TRUSTEES FOR ALASKA

July 1, 2019

Re: Comments on the Draft Environmental Impact Statement and Public Notice of Application for Permit Reference Number POA-2017-00271 for the Proposed Pebble Project

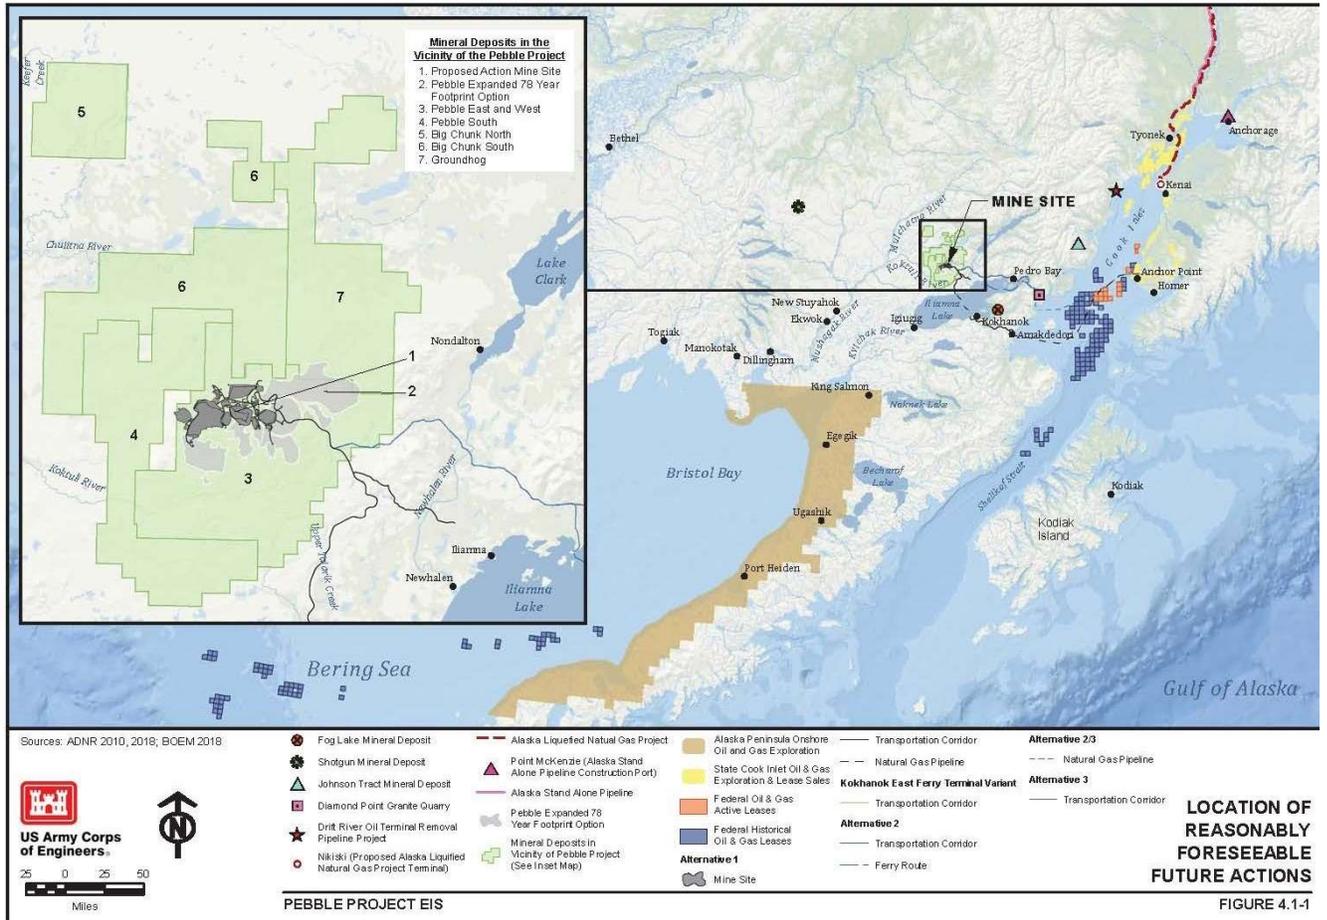
Figure 4.1-1 from the DEIS identifies surrounding mineral deposits. It becomes readily apparent that exploration of these other deposits surround the Pebble deposit and would benefit from PLP's infrastructure.

2019 Wobus Memo - Figure 6. Probability of a tailings storage facility failure vs time.¹⁴⁰⁷

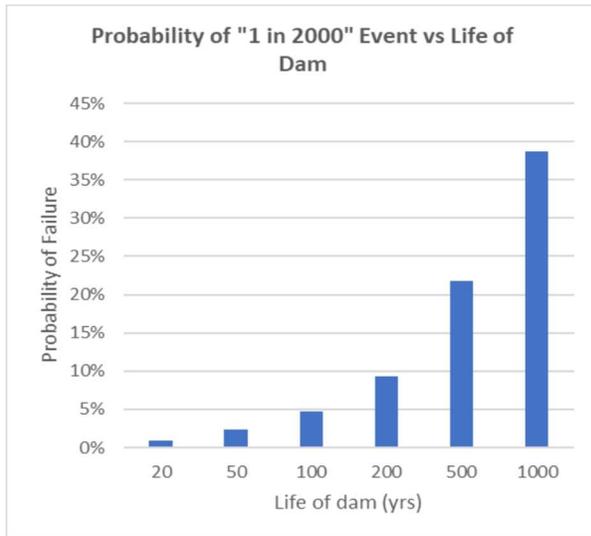
As noted above, the reasoning offered to preclude review of a variety of tailings failures, including complete failures of both north and south embankments, is inconsistent with the requirements of NEPA. Given that the 78-year mine is a reasonably foreseeable future action, the 20 years is an inappropriate time period; any assessment must at least analyze a 78-year life span and the potential cumulative impacts from an expansion from a 20-year mine to a 78-year mine. Those potential impacts include tailings failures. Further, since the water balance calculations indicate that the bulk tailing facility may remain saturated indefinitely, the risk of a tailings failure will remain in perpetuity.¹⁴⁰⁵ The DEIS indicates that the probability of a tailings storage facility dam failure is approximately 1 in 2000, for every year of dam's life.¹⁴⁰⁶

2019 Wobus Memo. - Figure 7. Tailings flood extent from median tailings dam failure scenario (Lynker, 2019)¹⁴⁴²

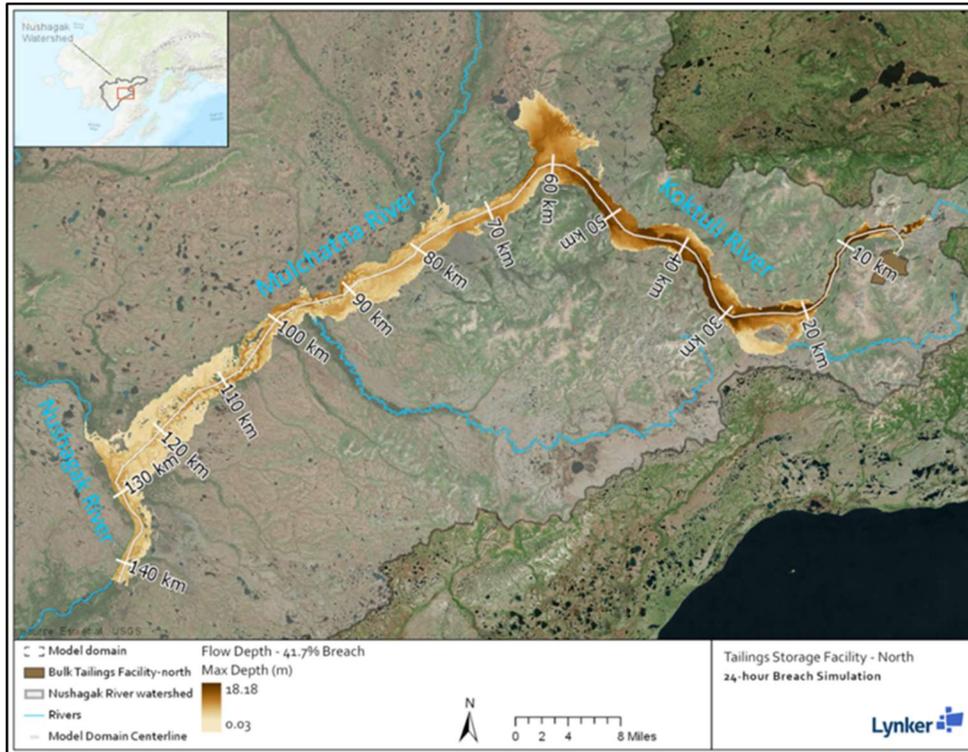
The Lynker tailings failure scenario "found that a full [tailings storage facility] failure could impact hundreds of miles of salmon-producing streams, with potentially catastrophic long-term consequences to salmon habitat" ¹⁴⁴¹ The Lynker study demonstrates that, despite the probability of failure, the consequences of such an event would be significant.

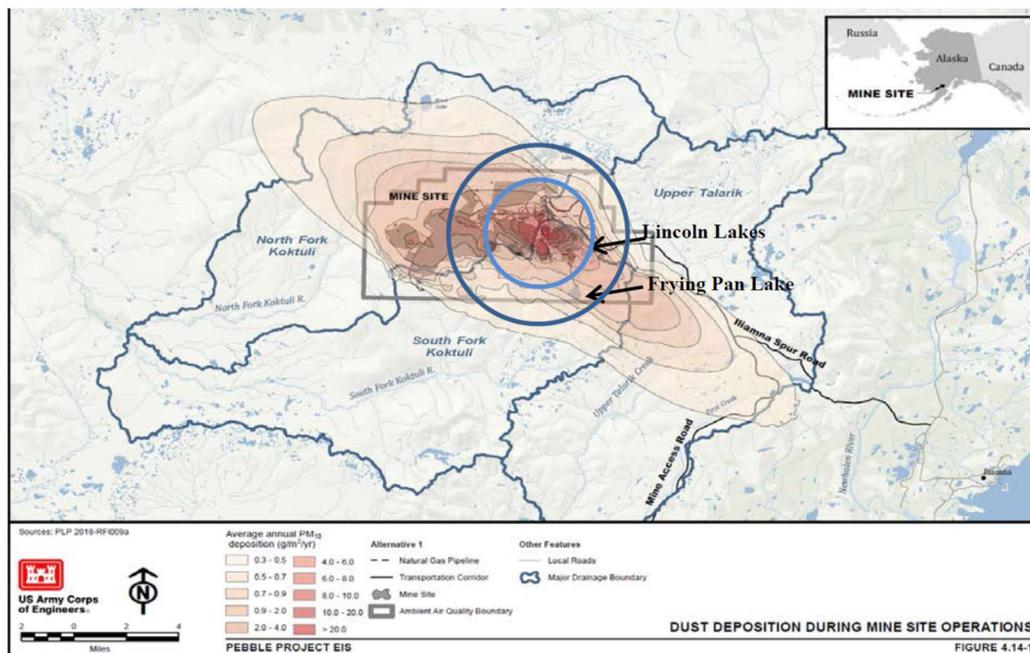
The DEIS analysis for the mine site is also limited by the arbitrary 330-foot dust zone. As discussed above, this limited impact analysis area fails to accurately capture and portray the anticipated dust impacts that will extend beyond 330 feet.¹⁶⁸⁸ Notably, the DEIS recognizes that dust will travel further than 330 feet through its depiction of mine site dust deposition in Figure 4.14-1.¹⁶⁸⁹ The following figure in the Zamzow et al. 2019 report includes an overlay of concentric rings at 2 and 4 miles out from the pit.¹⁶⁹⁰

As Dr. Zamzow notes, “In the Pebble Project DEIS, the 100 m zone was the sole source relied on to calculate the area of vegetation, wetlands, and water bodies impacted by dust, and is different from the dust plume map shown in Chapter 4.14.”¹⁶⁹¹ This is self-evident after looking at the expanse of dust deposition provided in the DEIS Figure 4.14–1. Because wetlands and water bodies will be impacted far beyond the 330-foot dust zone, the DEIS estimates are inaccurate and misleading. Because fugitive dust is considered a secondary or indirect impact that results in loss of wetlands under the CWA 404 permit review for this project,¹⁶⁹² the estimated indirect loss of wetlands for purposes of the 404 analysis is inaccurate.
